**RE: FTAA-2603-1185 HUNUA QUARRY DEVELOPMENT SUBSTANTIVE APPLICATION
LODGED UNDER FAST-TRACK APPROVALS ACT 2024 – UPDATES TO APPLICATION
FOLLOWING FURTHER CONSULTATION FEEDBACK**

PRELIMINARY COUNCIL RFI'S

TO	Cam Russell	FROM	Parviz Namjou
	Winstone Aggregates	DATE	18 May 2026
RE	Response to Groundwater Queries - Fast Track Application - BUN60464053

Figure 1: Bores Hydrographs and Sumps Water Levels

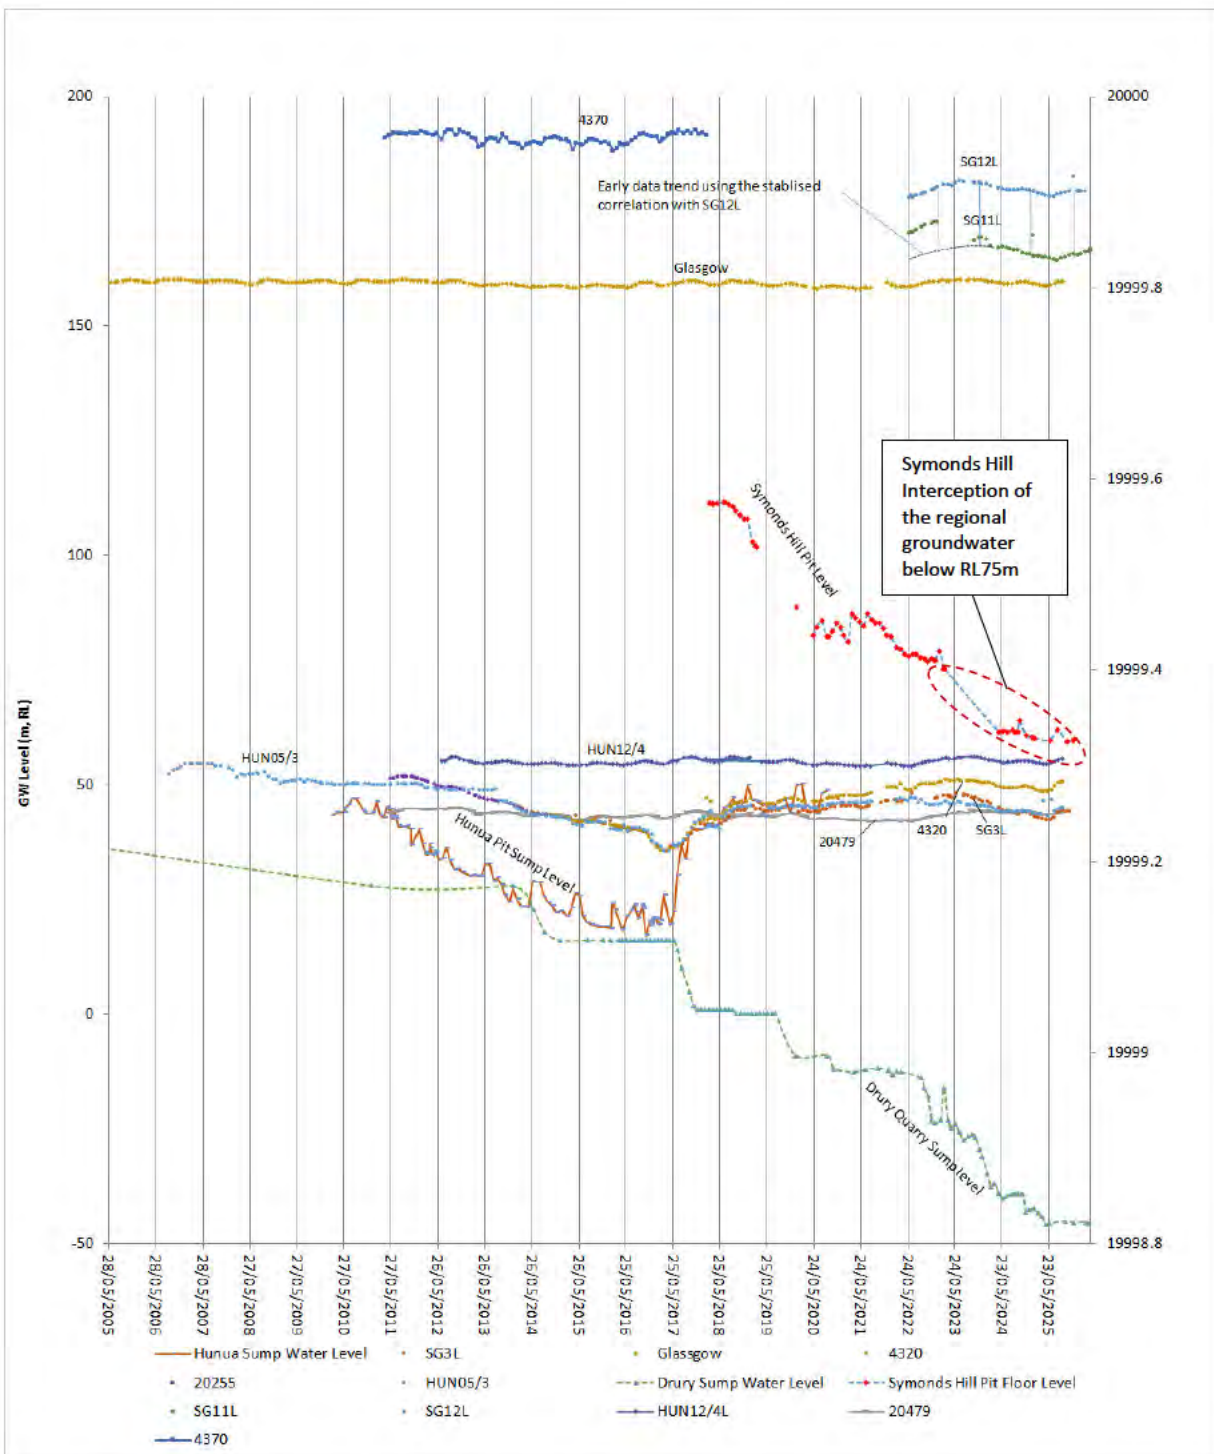
provide for replacement of monitoring bores in a timely manner <u>prior to</u> monitoring bores going dry. 10 Water quality results are indicated to be in Appendix C however none are presented. 11 S 4.1 There is no hydrograph for the Glasgow bore in Appendix B to compare against sump water levels. 12 Should Table 11 (minus bore already in Schedule A) be conditioned or attached as an Appendices to indicate for future reference bores existing at the time of the application that are potentially affected. This may preclude issues at a later date with subsequent bores drilled. 13 Based on a technical paper by Ferdowsian (2001) PDP use AMRR (Accumulative Annual Residual Rainfall) to suggest decline evident in these two bores is due to a decline in rainfall. I am not accepting of the use of this methodology for the deep greywacke bores when shallow bores in the vicinity of these deep bores do not show the same variation. The Glasgow bore has 29m of silts and clays overlying Waitemata sandstone/siltstone. The greywacke contact is at a depth of 68.5m and the bore cased to 71.5m. The Ferdowsian (2001) study was completed in the wheat belt of Western Australia with groundwater levels only 3m to 5m below surface. From my previous review work in the area shallow monitoring bores do not show this response. The methodology should be applied to the nearby shallow bore ID HUN05/2U to compare the results to HUN05/2L and the Glasgow bore. I would have thought the deep greywacke water age would be at least 30 years so not sure how you relate the current rainfall to much older groundwater. While I accept the low permeability of the Hunua Fault I consider there are drawdown effects occurring across the Fault. The effects have been delayed. See comments in (5) above. A conservative approach should be taken and effects assessed on this basis. 14 Consideration should be given to drawdown in the Glasgow bore and not rule it out categorically as in section 4.4.3. Although I note the Glasgow bore is included in Schedule A monitoring in the conditions with significant drawdown provided for. Hence the wording does not match the conservative but possible view presented in Schedule A. 15 The comment (pg40) that all bores responded to the Hunua Pit recovery is largely accepted however due to the higher permeability north of Drury Quarry there is a masking effect of the Drury Quarry drawdown which is clearly evident in Figure 7. I don't accept there has been no drawdown due to Drury Quarry in SG 3 and to the north and east. I agree the drawdown is largely confined by faults/low permeability barriers and the implications of this may not be significant but we are dealing with a 70 year plus mine life. A conservative approach should be taken and effects assessed on that basis. 16 Section 4.2.2. I don't accept Hun4/12 has not been affected by Hunua Pit dewatering given the hydrograph presented in Appendix B. Advise that a plot of the hydrograph against Hunua pit groundwater level is provided. Note the level change in bore HUN4/12 is approximately 30m with levels recovering at the same time as the Hunua Pit. A conservative approach needs to be taken here and effects assessed on that basis. 17 Section 4.2.1 refers to bores 4370 and 20479 however no hydrographs have been provided for these. Plots against Hunua Quarry drawdown should be provided in Appendix B.

As requested, hydrographs for SG11L, SG12L, Glasgow, HUN12/4, and the Symonds Pit, Hunua Pit, and Drury Quarry sumps are shown in Figure 1 of this memorandum.

Both hydrographs for SG11L and SG12L show a similar trend except for a six-month period immediately following drilling. Following the drilling, a sharp rise in groundwater levels is detected which does not correlate with any of three sumps water levels. As shown in Figure 1, the initial elevated data in SG11L is clearly out of sync with the remainder of the data for both bores, suggesting the early SG11L data may have not been stabilised following the drilling and may be inaccurate. From the end of 2023, the data from SG11L is in sync with SG12L, confirming the initial data may not be representative. The corrected hydrograph for SG11L is shown in Figure 1.

If the fluctuations in these bores were caused by Drury Quarry dewatering, the hydrographs should not have been risen after Drury Quarry Sump was stabilised from 2025. However, since 2025, when the Drury Quarry pit stabilised at RL-45m, both SG11L and SG12L show an upward trend and no relationship with Drury Quarry dewatering. The observed fluctuations are therefore consistent with long-term seasonal trends rather than dewatering.

Revision notes:			Drawn by:		Project:		Date:				Figure: 1
Rev:	Date:	Notes:	HA J003408		489 Hunua Road, Hunua, Auckland Hunua Quarry Development		19 May 2026				
			Client:		Drawing Title: Access Upgrade		Scale @ A3: 1:800				
							Revision: A

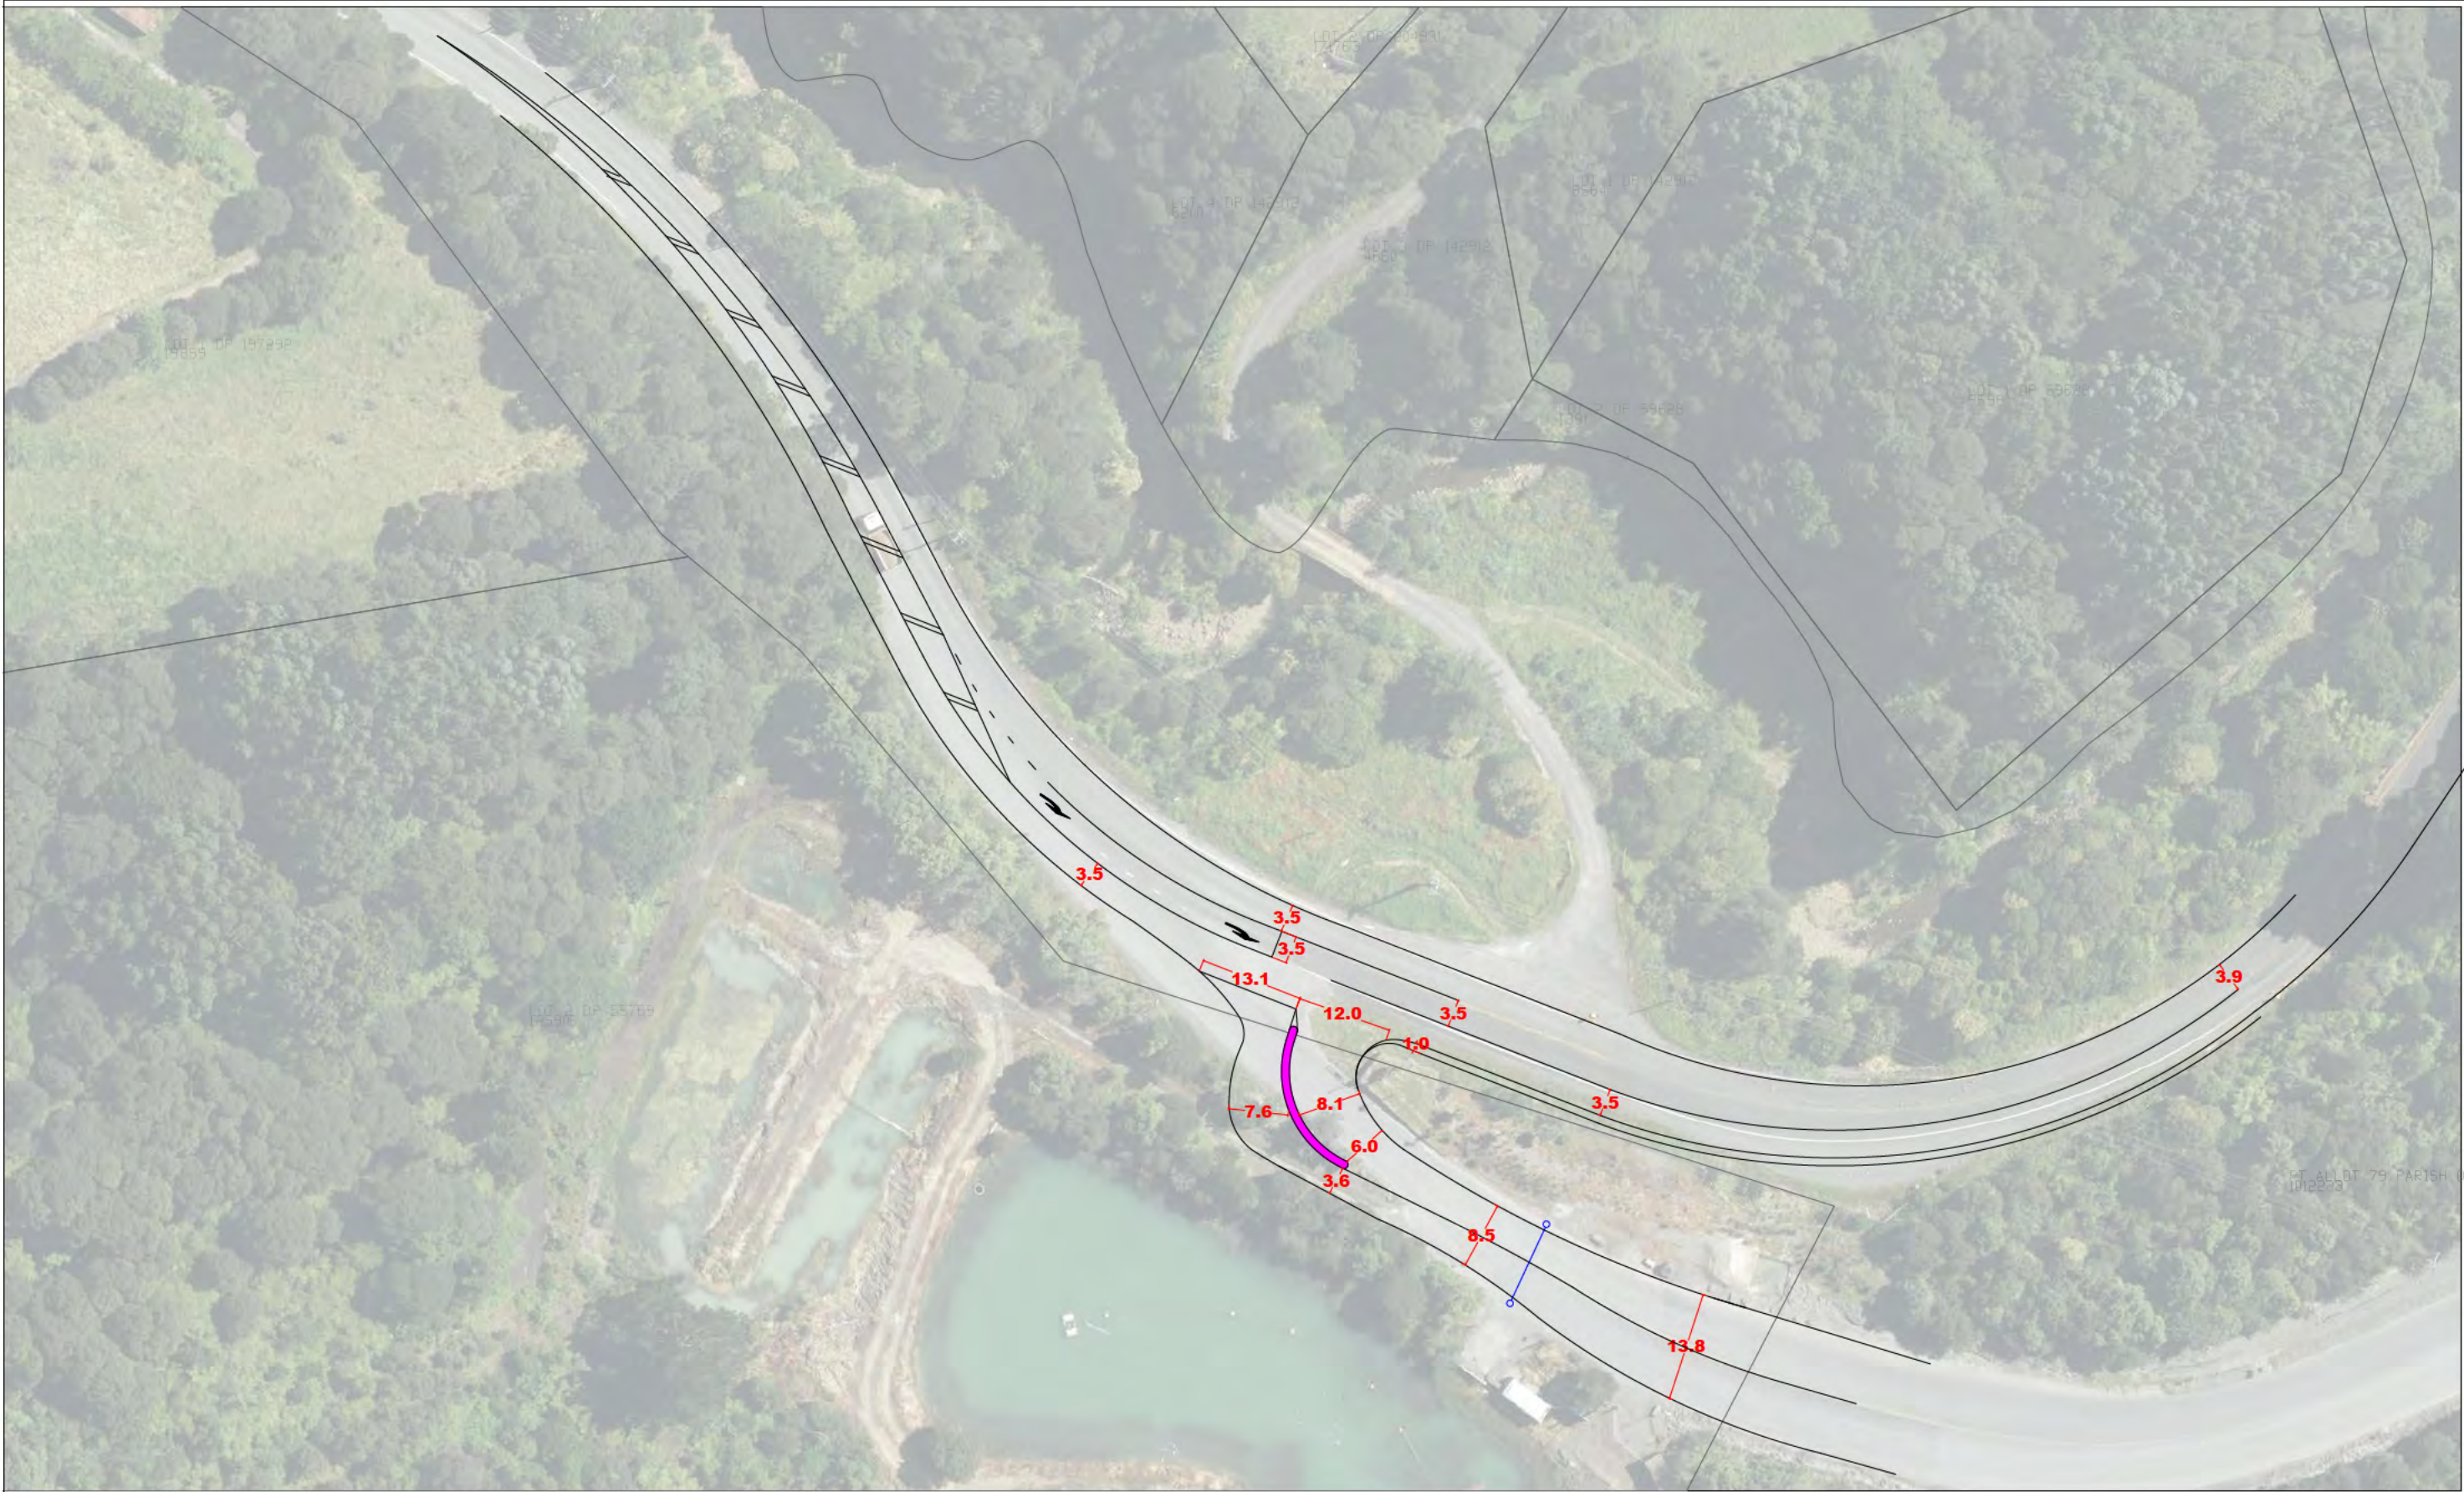
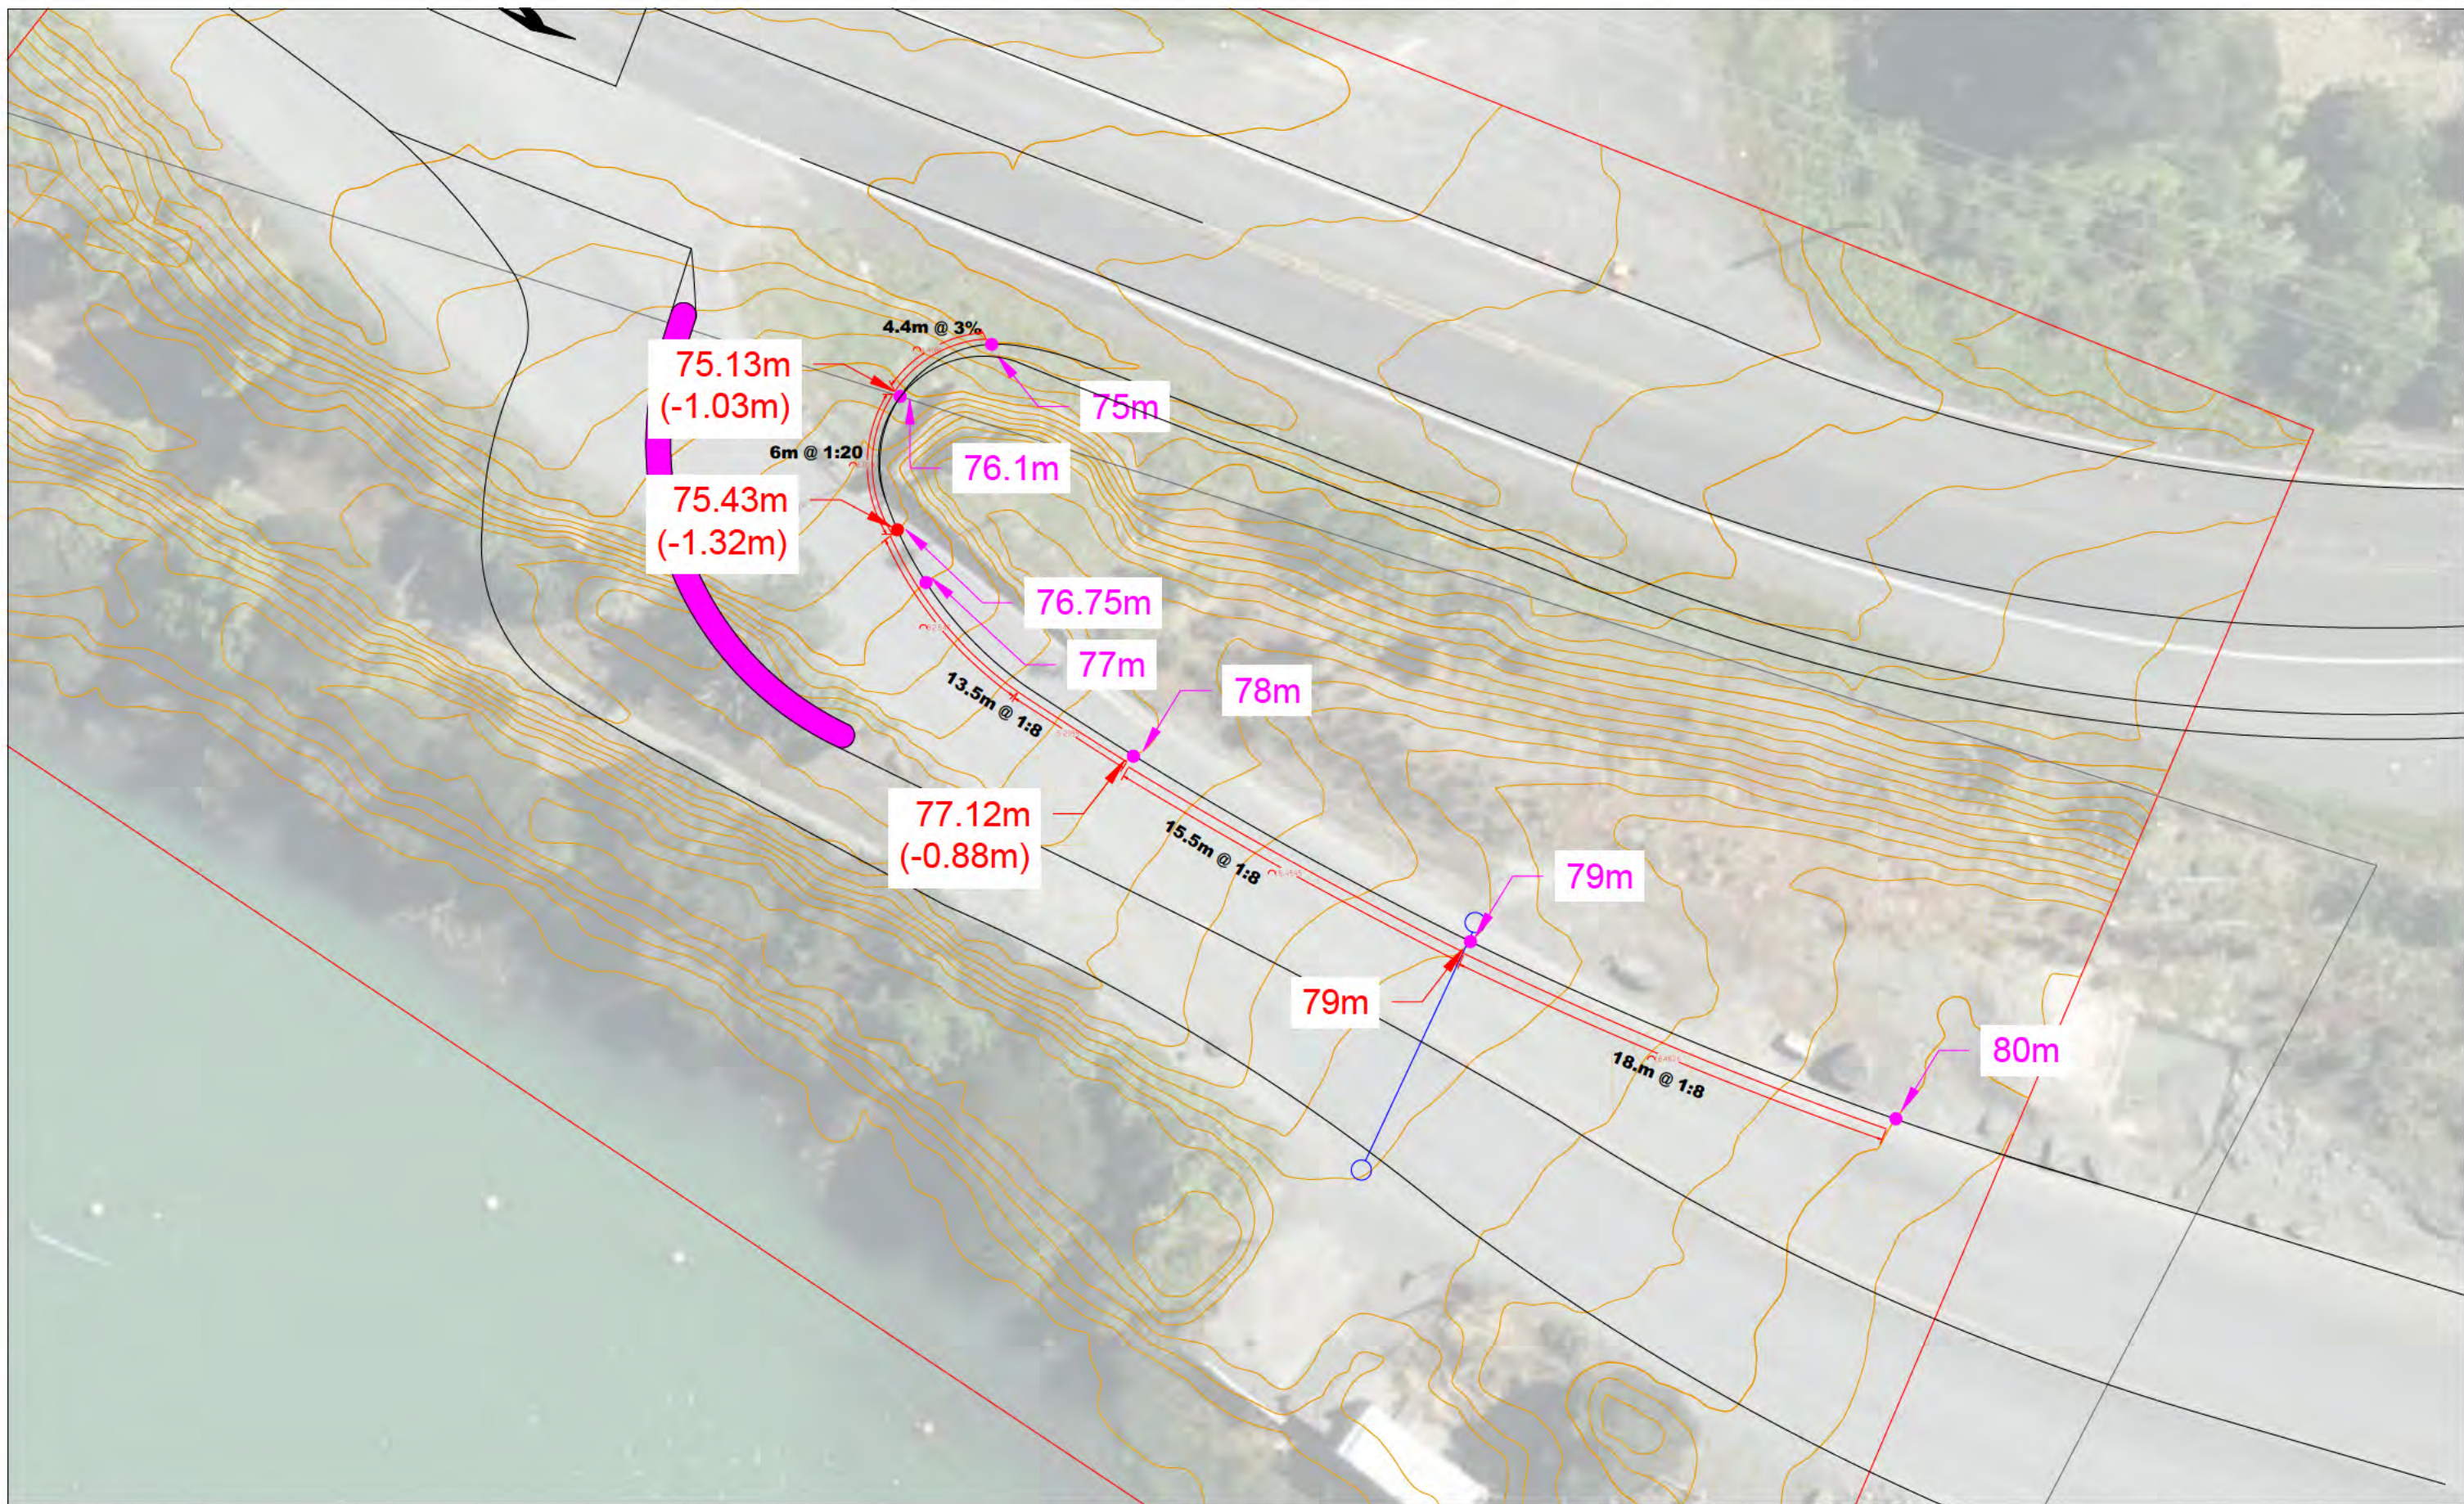
Truck tracking has been provided for all movements except for right-turn movements exiting the site access. While AT generally accepts the traffic engineer's assessment and acknowledges that few trucks are expected to turn out in this direction, it would be helpful for the applicant to provide a drawing demonstrating that this truck-tracking movement functions appropriately and does not overlap with a truck of the same size turning left into the site.	Revised plans provided in the Commute memo dated 16 June 2026.
